Voltage Regulator Failures - 135 thru 200

Mariner and Mercury

1992 and 1993 135 thru 200

S/N 0D082000 thru 0D254352

Figure 1. Voltage Regulator

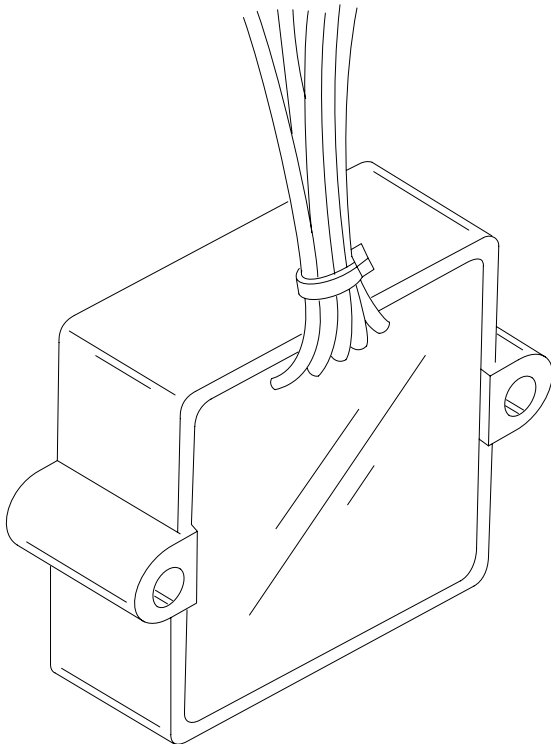
The models listed have experienced a higher than normal number of voltage regulator failures. The cause has been found to be overheating of the regulator. This occurs when using a high amount of current and/or outboard operation in warm waters.

Models listed should have an adaptor p/n 824715 installed under both voltage regulators. The adaptor will allow the voltage regulator to fully contact the exhaust plate and dissipate the heat quicker.

Figure 2. Date Code Location

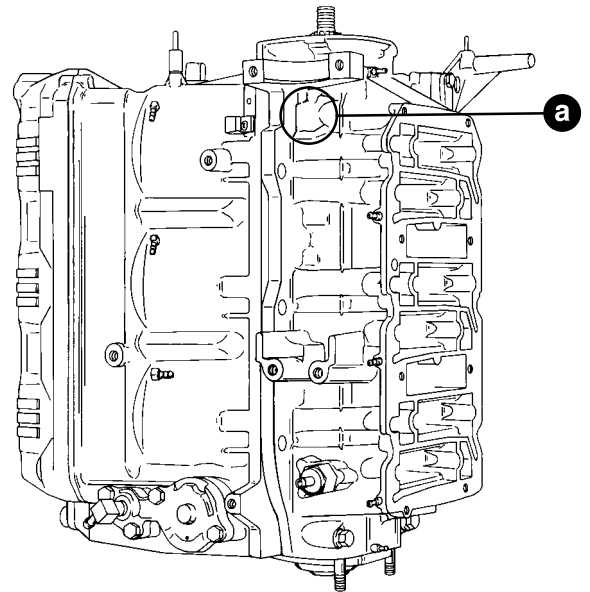
Outboards starting with serial number 0D254353 and above and replacement powerheads with date code 1/23/93 and later (Figure 2) have an improvement to the exhaust plate to prevent the regulator from overheating. The improvement involves machining the voltage regulator mounting area to allow the regulator to fully contact the exhaust plate and allow the heat to dissipate faster and more efficiently.

Figure 3. Voltage Regulator Location

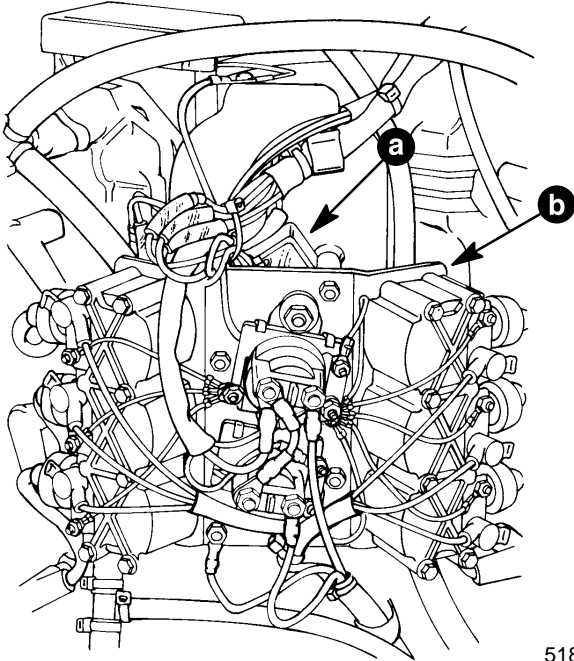
- removal of the ignition plate at the rear of the motor (Figure 3).

Figure 4. Adaptor P/N 824715

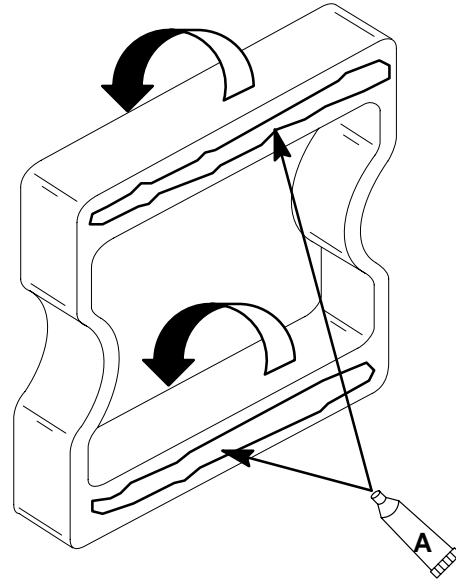
- applying silicone dielectric grease p/n 92-823506--1 on both sides of the heavy contact rails (Figure 4.)

a - Apply Dielectric Grease p/n 92-823506--1 on both Sides.
